Access Compliance Report

Public Rights-of-Way

| Intersection ID: 11148 | Main Street: MATHESON_AV | Cross Street: VIRGINIA_AV | Location: | N |
| ADA ID: 929179D0C502 | Ramp Type: PerpDiag | Initial Pass/Fail: Fail | Overall Compliance: No | Severity Score: 33.75 |

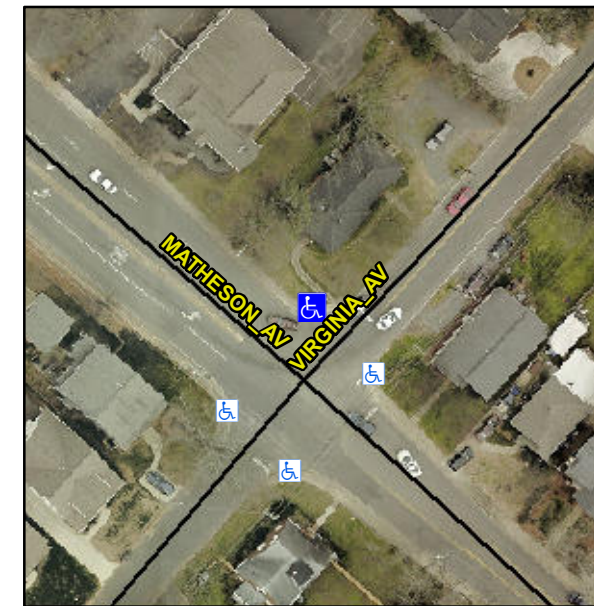
Not Found, R304.5.1, R304.5.3

| Compliance | Description | Data | Compliance | Description | Data |
|------------|-----------------------|-------|------------|-----------------------------|-------|
| N/A | Ramp Length (in) | 49.0 | Yes | Ramp Slope (%) | 5.8 |
| No | Ramp Width (in) | 39.5 | No | Ramp XSlope (%) | 10.0 |

Remove & Replace Curb Ramp With Two New Directional Ramps or Equivalent.
